ACTIVE.T motorised desks

Support struts for
desk depths of 900 and 1000 mm

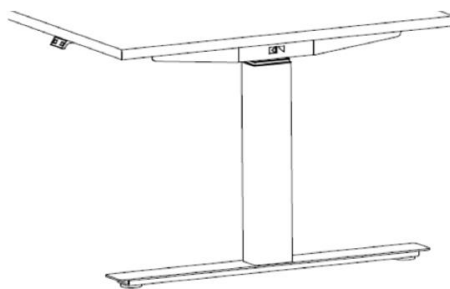
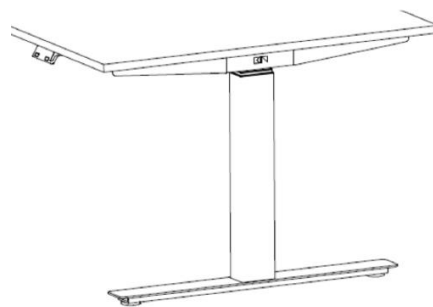
ACTIVE.T desks of depth 900 mm and 1000 mm will be fitted with a longer side support strut.

The main purpose of this optimisation is to improve stability. Prices and data remain unchanged.
